## **Response to queries raised by Andy Aylott (AA) at the Gateway 14 Stakeholder Meeting 28/02/24.**

AA comments are in bold and italics, with Gateway 14 responses below.

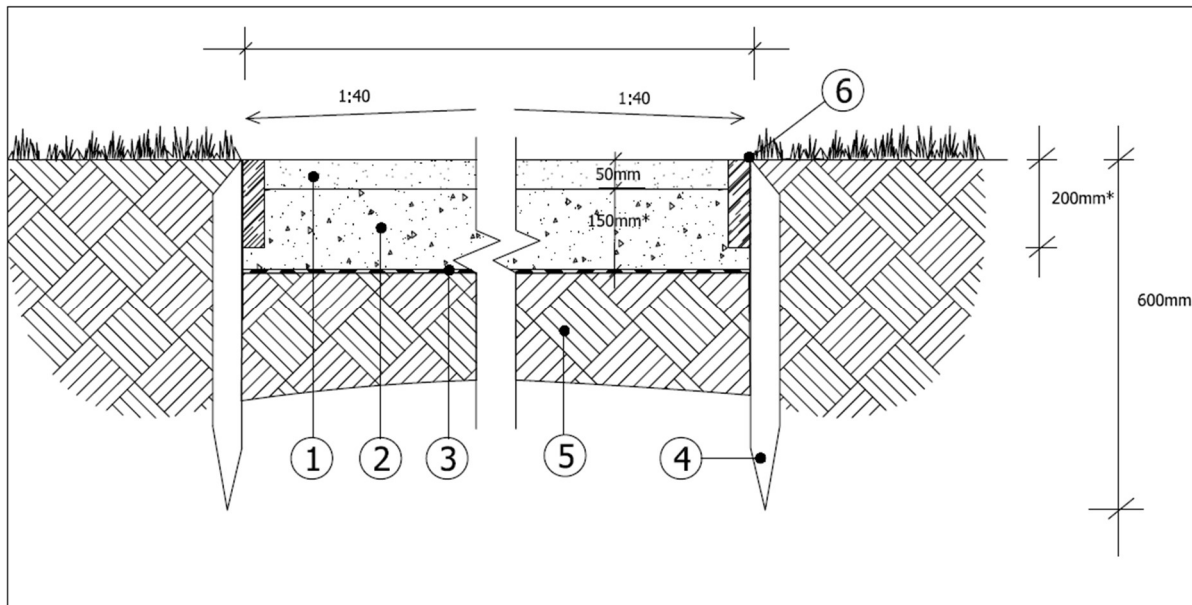
***Initially raised at previous residents meeting that the mats were dangerous, and attempts made to glue down throughout the spring/summer but clearly not fit for purpose.***

The plastic tactile slabs were specifically requested by SCC Highways as part of the approved scheme.

Subsequently following a review, these have been replaced on Gateway Boulevard for concrete tactile paving due to an issue with the adhesive.

The plastic tactiles on Gateway Road and Gateway Drive have been remediated and will remain as laid. The images shared by Andy Aylott are now historic and were taken before our contractor repaired them.

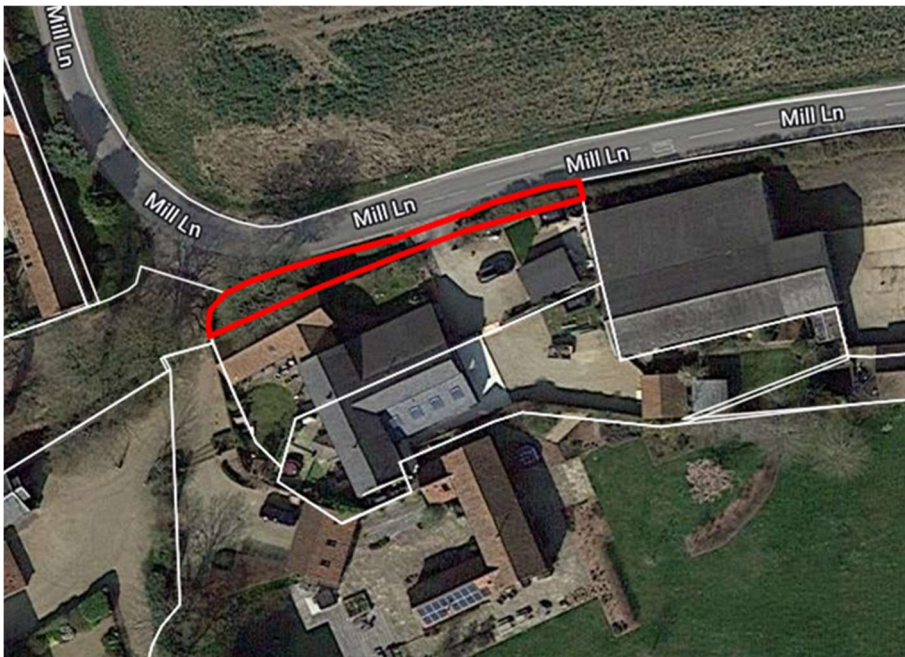
From our survey on Wednesday 28 February 2024, the ditch opposite the bend looks like it's never been maintained and is clearly silted up with leaves and debris. The section adjacent to the retaining wall looks completely blocked and impassable for water.

We are aware Mex Homes Ltd owns the absolute freehold title of this strip land including the ditch and access road. Shown red below for clarity. There may be responsibilities within the titles of the adjacent properties with regard to the maintenance of this ditch- it would be helpful if residents could check their title documents.

Is there a regular maintenance regime for this ditch and if so, what is the regularity of the maintenance? How many times has this been cleaned out? Subject to residents' title investigations have you approached Mex Homes or the other residents with responsibilities?
